**RE: Subgrade Inspection for Lot # 104 Pergola Park – 3217 SW Mary St  
Lee's Summit, MO 64081 – Permit # 2020-4953**

On January 20, 2021, a special inspection was performed by Residential Engineering Services, LLC (R.E.S.) at the above referenced property. The purpose of this inspection was to determine structural adequacy of the existing soil for construction of concrete foundation.

SPREAD FOOTING  
DETAIL  
N.T.S.

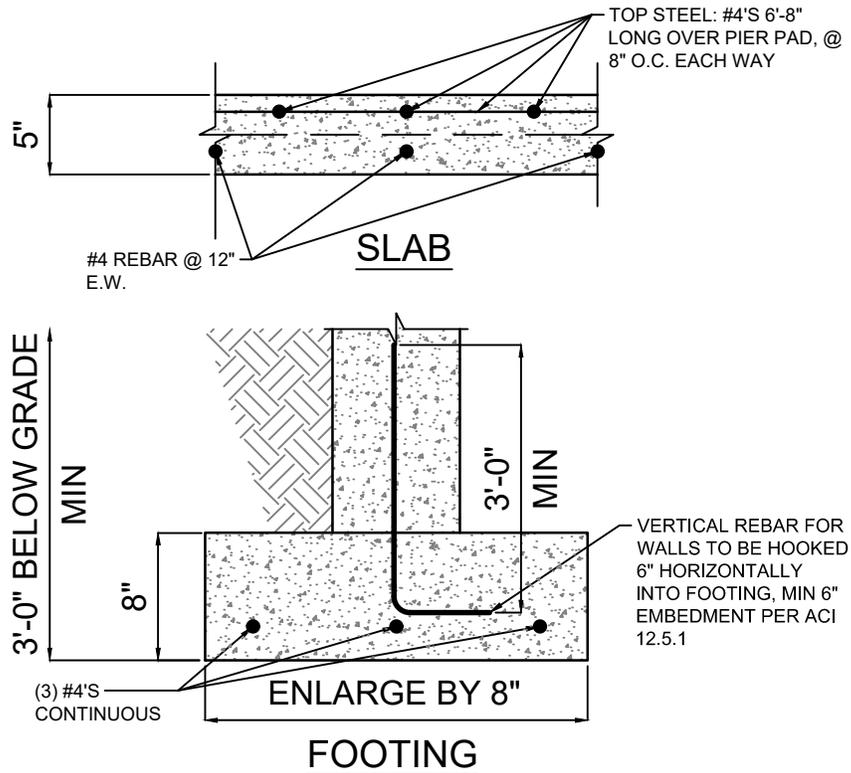
- The soils observed at footing elevation were silty clay; light brown; low plasticity and dry.
- Probes and penetrometer readings indicated that the soils do not have sufficient bearing capacity for the loads applied by foundation per permit plans.

- RES recommends that the footings on the rear 1/3 of the lot be enlarged to 24"x8" with three (3) #4 rebar continuous (see attached specifications)
- Applicable basement and garage pier pads in area of concern shall be enlarged a minimum of 6" each way (i.e existing 30"x30" shall be enlarged to 36"x36", etc.) (see attached specifications)

NOTE: PIER PAD SCHEDULE HAS BEEN INCREASED WITH THE USE OF THIS SPREAD FOOTING DETAIL. TABLE IS BASED ON RES SPECIFICATION REFERENCES AND MAY NOT DIRECTLY TRANSLATE TO PLANS ENGINEERED BY OTHER FIRMS. REFER TO SITE SPECIFIC DESIGN FOR PIER PAD SIZES.
